SUBMISSION RELATING TO DEVELOPMENT APPLICATION FOR 241-249 WHEAT ROAD, COCKLE BAY

1. This constitutes an objection to the development proposed at 241-249 Wheat Road, Cockle Bay. It is made on behalf of the residents of One Darling Harbour, Pyrmont, who directly face this site.

PHOTOMONTAGES FROM THE EIS ILLUSTRATING THE DOMINANCE OF THE TOWER BUILDING OVER THE BRIDGE

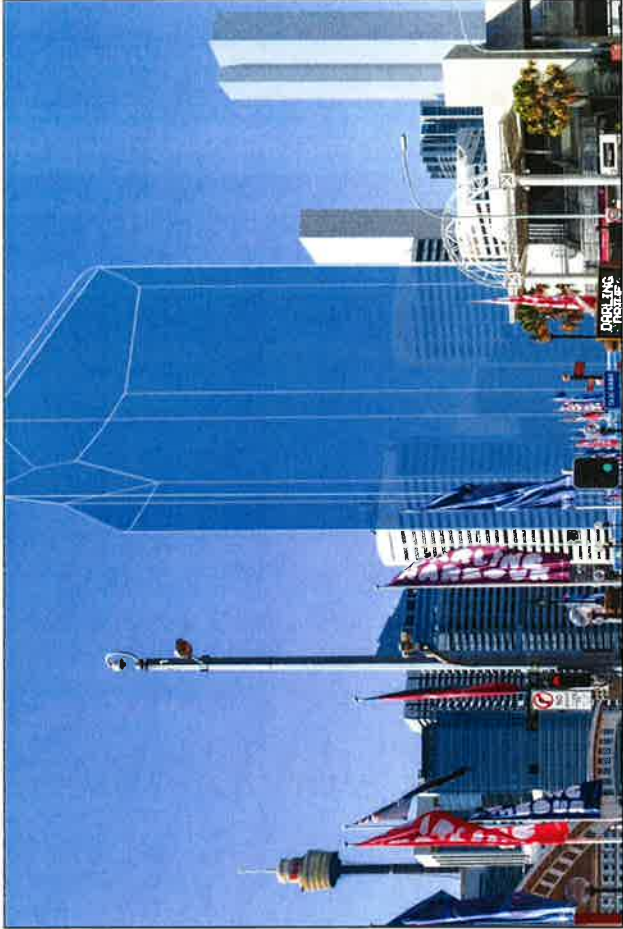
18. The EIS argues that the verticality of the tower will complement the horizontality of the Bridge. But it will stand as a very fat goal post, which must damage the significance of the Bridge. It will be seen as a very large vertical element compared with the more graceful receding horizontal form of the Bridge.

20. Attached as Appendix I are images included in the E.I.S. illustrating the impact of the proposed tower on the context of Pyrmont Bridge. How it can be said that the tower will complement the heritage of the Bridge is difficult to understand.

19. If a tower is to be built at all, it needs to be set back to at least as far as the western edge of the Western Distributor. Because it is located in the context of Darling Park it needs to be a smaller tower.

Building Envelope - 3D View 2

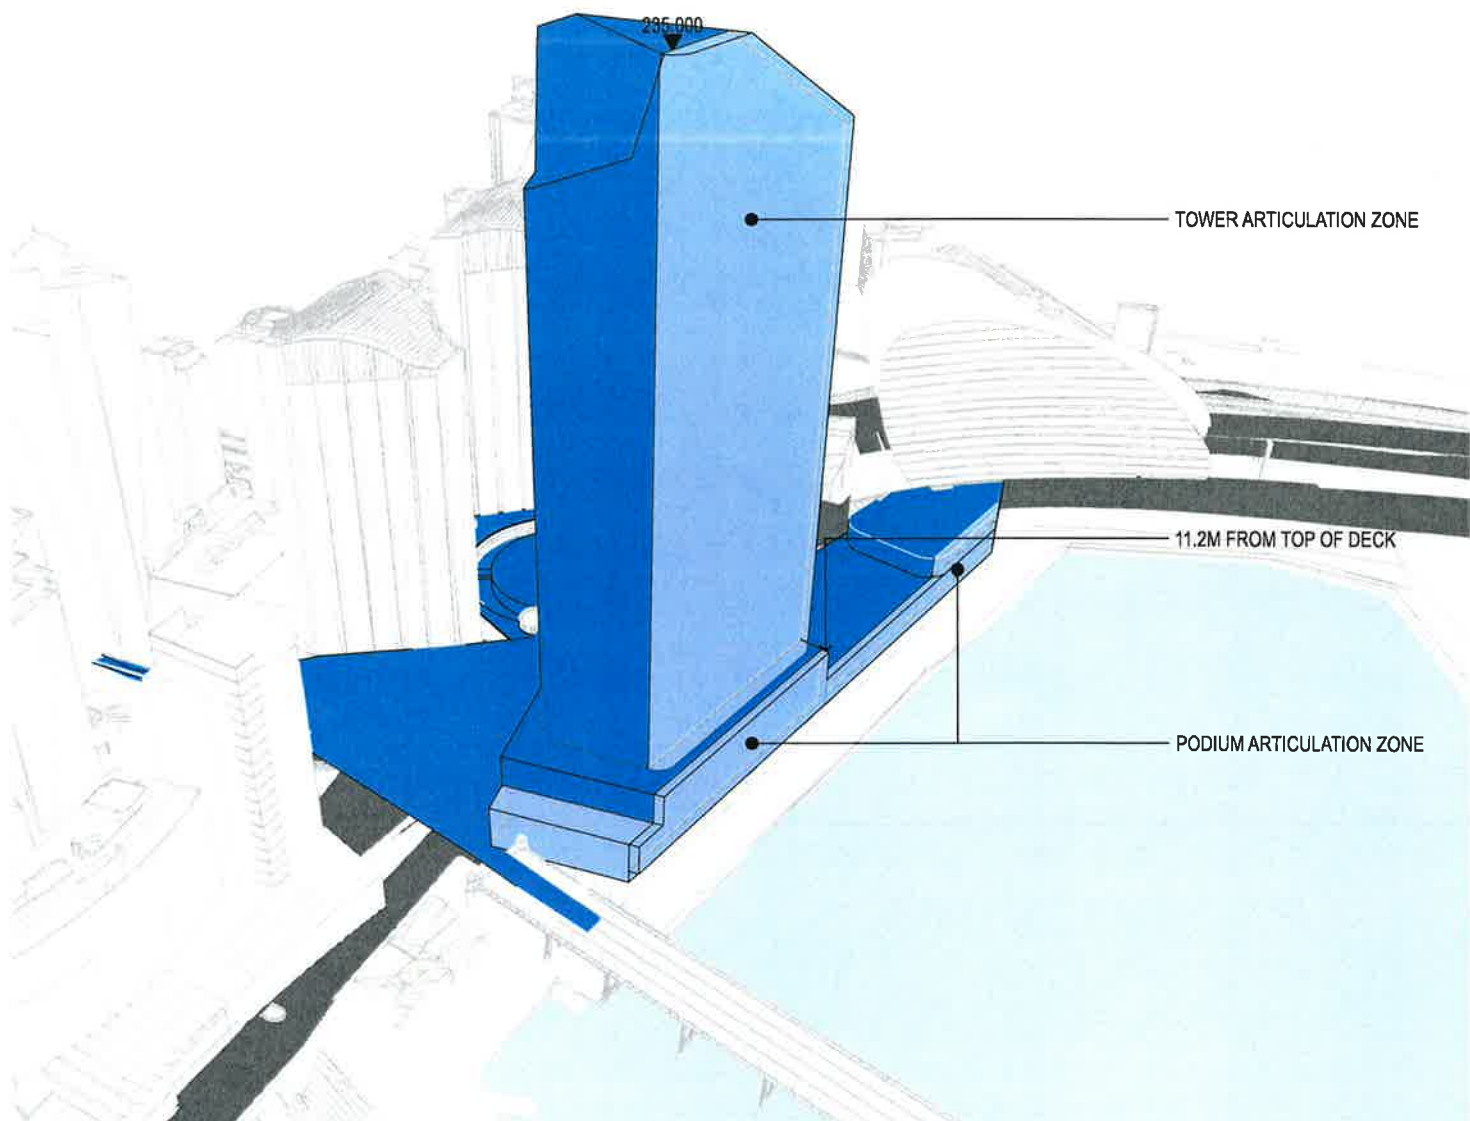
17. The problem which arises is that the proximity of the proposed tower building will dominate Pyrmont Bridge and diminish the heritage significance of the Bridge.

21. Attached as Appendix II are images included in the E.I.S. illustrating the relationship between the tower building and Pyrmont Bridge, together with the relationship with the existing Darling Park buildings and the proximity to the exceptional heritage qualities of Darling Harbour.
